**Chippenham Cycle Network Development Group (Cycle Chippenham)
Response to Planning Application: PL/2025/09200
49, 51 & 53 (Rowden Hill House), Rowden Hill, Chippenham, SN15 2AN**

Full: Redevelopment and renovation of the existing site to provide, within the retained buildings: 1 detached dwelling, 5 flats, A terrace comprising 4 dwellings, alongside the erection of 1 self-build detached dwelling. A new one-way access road, Parking areas and footpaths, External landscaping and associated works, Installation of photovoltaics and air source heat pumps and site drainage features.

Cycle Chippenham response

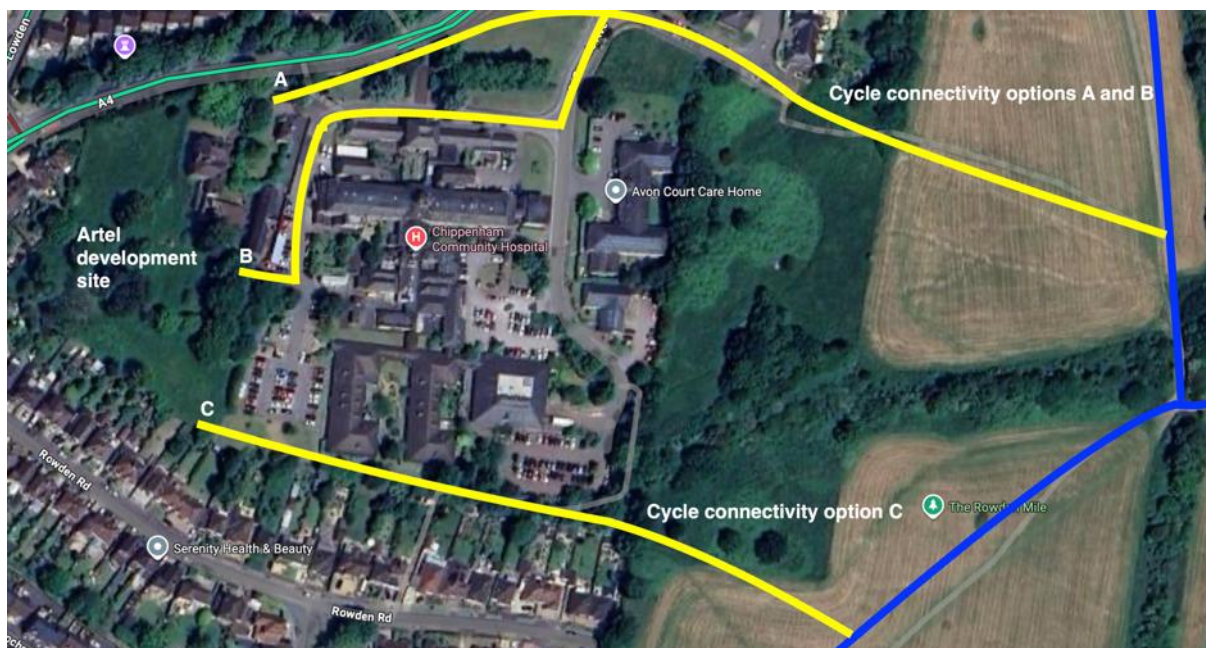
As outlined above, there is no legal way to cycle to the site that would not result in significant highways safety risks, by requiring vulnerable people to cycle on one of Chippenham's busiest roads.

Requirement: To address this, the applicant needs to provide a link from the development site to the town's wider cycle network. The simplest way to achieve this would be to link to the Rowden Mile (shown in blue), along one of the routes shown in yellow the image below (A, B, or C). All of these would require the cooperation of the NHS, due to the routes passing over Chippenham hospital land.

If these links via the hospital site are not feasible, then another option, to get people from the development site to the town cycle network, via routes classed by LTN 1/20 as 'provision suitable for most people' must be provided as part of the site access requirements instead.
